SUBJECT: WOLF CREEK GENERATING STATION – STAFF ASSESSMENT OF  
RESPONSE TO 10 CFR 50.54(f) INFORMATION REQUEST – FLOOD-  
CAUSING MECHANISM REEVALUATION (CAC NO. MF3648)

STAFF ASSESSMENT BY THE OFFICE OF NUCLEAR REACTOR REGULATION

RELATED TO FLOODING HAZARD REEVALUATION REPORT

WOLF CREEK GENERATING STATION

Figure 3.4-2. The Neosho River Watershed and Dams Identified by the NRC Staff.

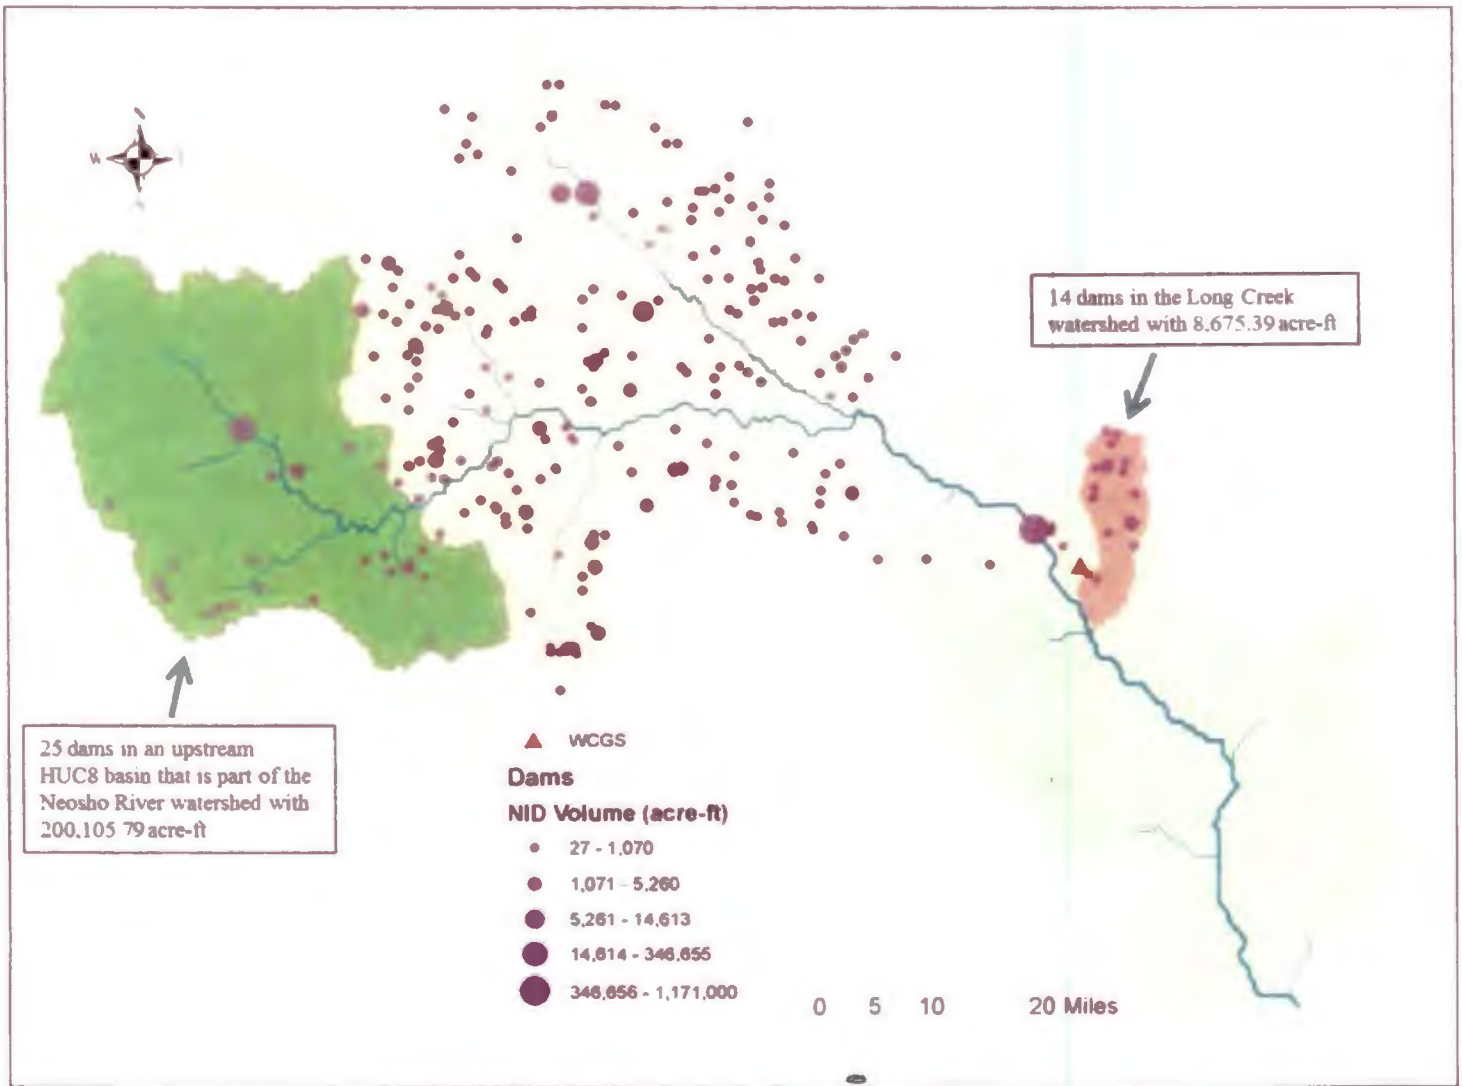
During review of the Neosho River watershed upstream of its confluence with Wolf Creek, the NRC staff discovered that the licensee did not include 25 dams that are located within the level-8 hydrologic unit code (HUC) 11070202, which is part of the Neosho River Watershed, in its analysis (Figure 3.4-2 of this assessment). Also, the licensee included 14 dams located in two level-12 HUCs, 110702040102 and 110702040103. These two level-12 HUCs are part of the Long Creek drainage that discharges to the Neosho River downstream of its confluence with Wolf Creek. Therefore, the NRC staff removed the 14 dams located in the Long Creek drainage. Including the 25 dams located in level-8 HUC 11070202 and excluding the 14 dams located in the Long Creek drainage, the NRC staff determined that 242 dams exist in the Neosho River watershed upstream of the confluence of the Neosho River with Wolf Creek. The NRC staff applied the Volume Method and estimated that the stillwater surface elevation would be [REDACTED] MSL, which is slightly higher than the licensee's estimate of [REDACTED] MSL (Table 3.4-1 of this assessment). From an inspection of the elevations along the ridge separating the Neosho River and Wolf Creek watersheds, the NRC staff determined that the increased stillwater surface elevation would not result in lateral overflow from the Neosho River watershed into Wolf Creek Lake. The NRC staff estimated the stillwater surface elevation also would be lower than the Wolf Creek Dam Main spillway crest elevation of 1,088.0 ft. MSL.
